Current Zoning: N1-A (neighborhood 1-A)
Proposed Zoning: N1-E(CD) (neighborhood 1-E, conditional)

Approximately 1.988 acres located at the deadend of Pickway Drive, west of North Graham Street.

The petition proposes to develop five duplex buildings on parcels that are mostly vacant with one single family home.

PLANNING STAFF REVIEW

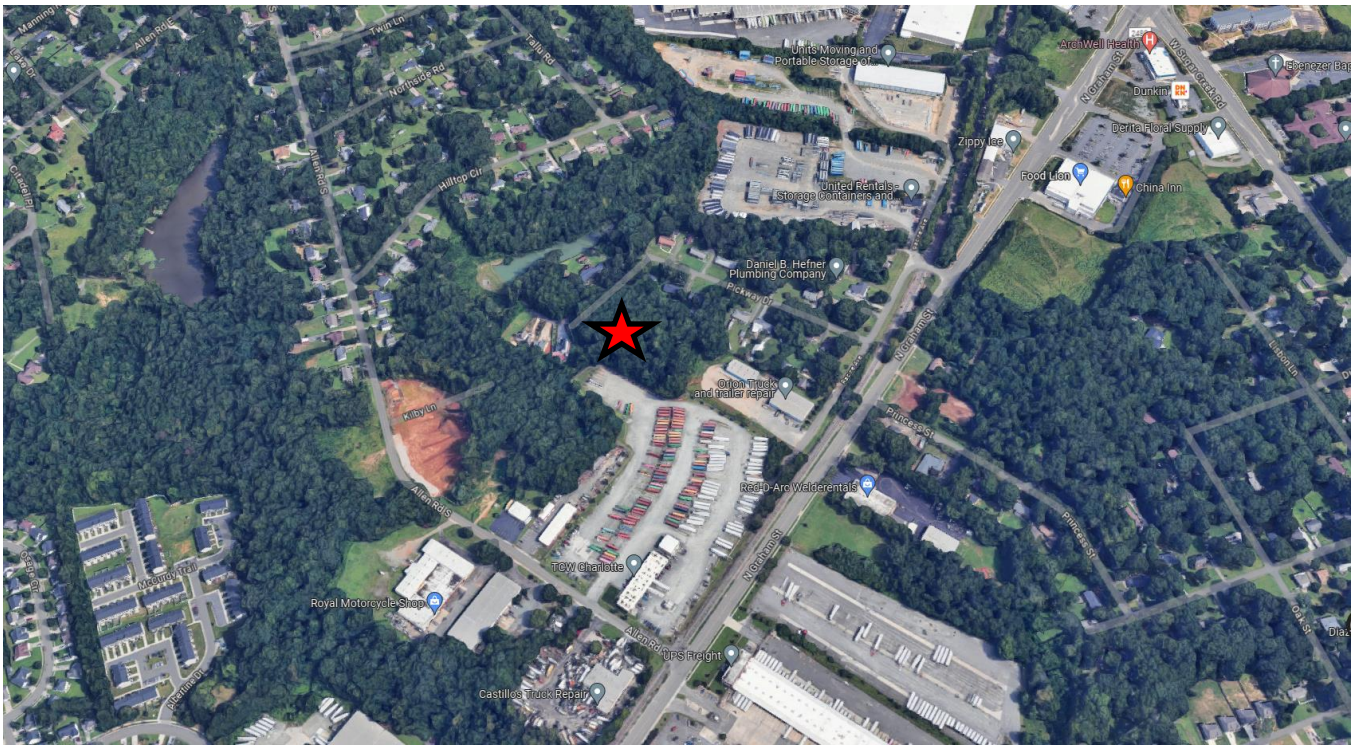
- ~~1. Revise site plan and conditional notes to commit to dedicate 31.5 feet of right of way from the road centerline. Label and dimension the right of way from the road centerline on the site plan.~~
Addressed
- ~~2. Revise conditional notes to commit to an 8' planting strip and 6' sidewalk per the CLDSM U-03A2 along Pickway Drive per UDO Article 33. The sidewalk should extend across the entire frontage, including at the intersection of the proposed public street and Pickway Drive as well as fully to property line.~~ **Addressed**
- ~~3. Revise conditional notes to commit to milling and overlaying the entire section of Pickway Drive across the development frontage.~~ **Addressed**

- ~~4. Specify in the conditional notes what type of planting standards will be provided in the rear setback against PID 04517220 and along the side of lot 4C. Consider adding conditional notes for planting standards that mirror the standards outlined for Class B or Class C Landscape Yards. Add a 6' opaque wooden fence along the site's boundary against PID 04517220.~~ **Addressed**
- ~~5. Add a 6' opaque wooden fence along the site's boundary against PID 04517209.~~ **Addressed**

~~6. Modify the driveways shown for the triplex buildings to be compliant with Article 19.6.A.1.a.~~

~~7. Correct the listed zoning of PID 045-172-20 to ML-1.~~ **Addressed**

~~8. Clearly distinguish and label each building as being on its own lot. Sublots for the individual units should be distinguished by dashed lines.~~ **Addressed**

Addressed
